**LEGAL ADVERTISEMENT
PORTLAND PLANNING BOARD MEETING
REVISED AGENDA**

PLANNING BOARD REPORT PORTLAND, MAINE

Final Level III Site Plan

Submitted to: Portland Planning Board Public Hearing Date: July 25 th , 2017	Prepared by: Jean Fraser, Planner Date: July 21 st , 2017
--	---

SHERIDAN STREET ELEVATION

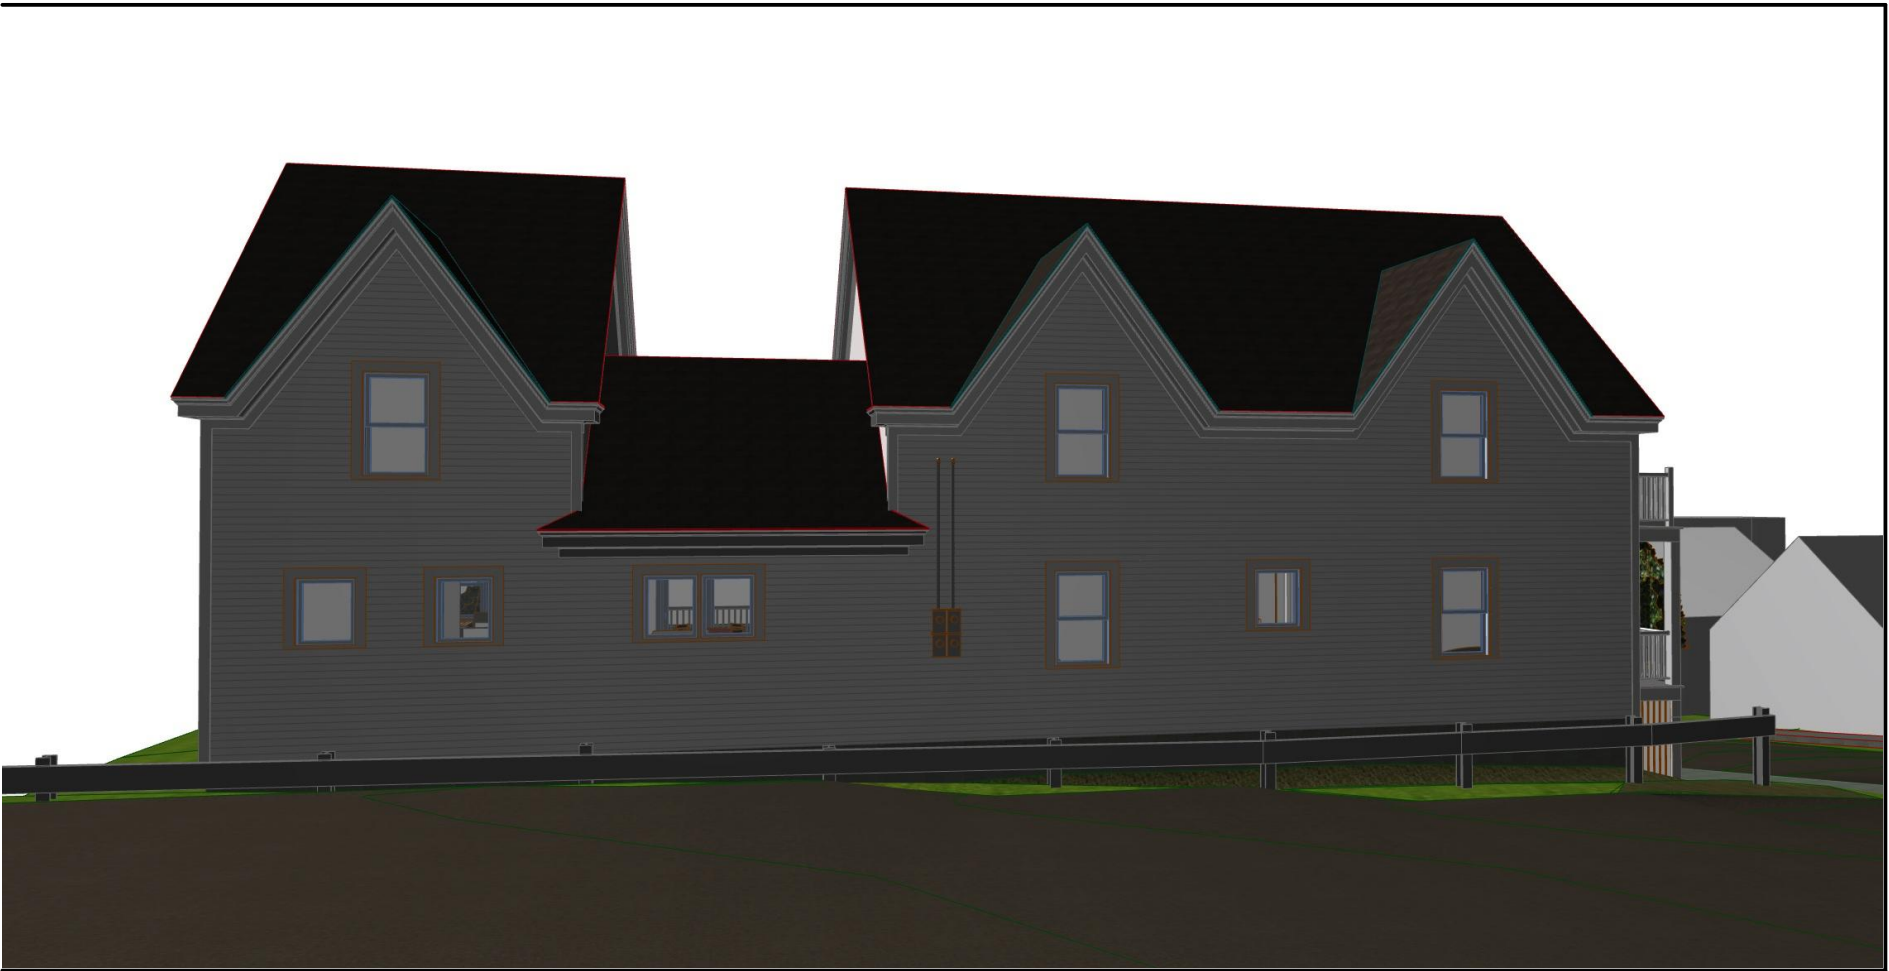
- CHANGES TO ELEVATIONS:
- ADDED PORCH ROOF
 - CHANGED WINDOWS ON SHERIDAN TO ALL DOUBLE-HUNG UNITS AND INCREASED SIZE
 - REMOVED GUARD RAIL
 - ADDED FOUNDATION PLANTINGS AND STREET TREE
